SUBJECT: Entergy's Third Six-Month Status Report in Response to March 12, 2012
Commission Order Modifying Licenses with Regard to Reliable Spent Fuel
Pool Instrumentation (Order Number EA-12-051)
River Bend Station – Unit 1
Docket No. 50-458
License No. NPF-47

**River Bend Station's (RBS) Third Six-Month Status Report for the Implementation of
Order EA-12-051, Order to Modify Licenses with Regard to Reliable Spent Fuel Pool
Instrumentation**

Figure 1: SFP Plan View

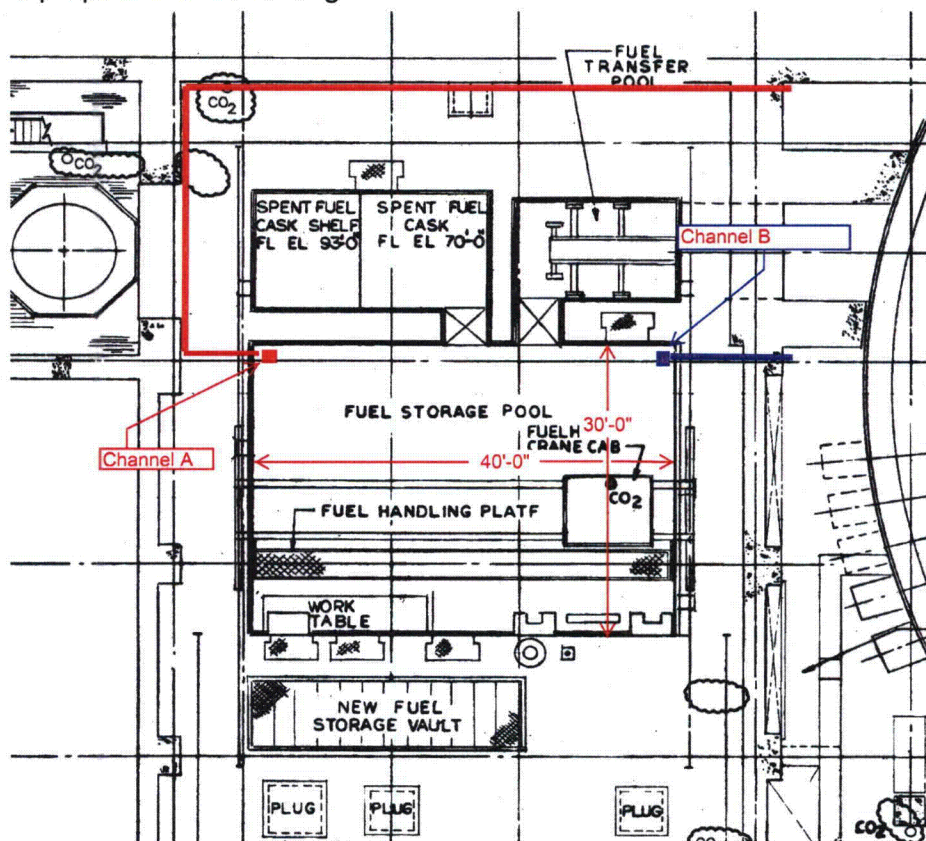
Please provide the updated sketch or marked-up plant drawing of the SFP level instrumentation arrangement. Include the plan view of the SFP area, depicting the SFP inside dimensions, the planned locations/placement of the primary and back-up SFP level sensor, and the proposed routing of the cables that will extend from these sensors toward the location of the read-out/display device.

Figure 1 shows the approximate locations of the SFPI probes, the inside dimensions of the SFP, and the proposed cable routing.
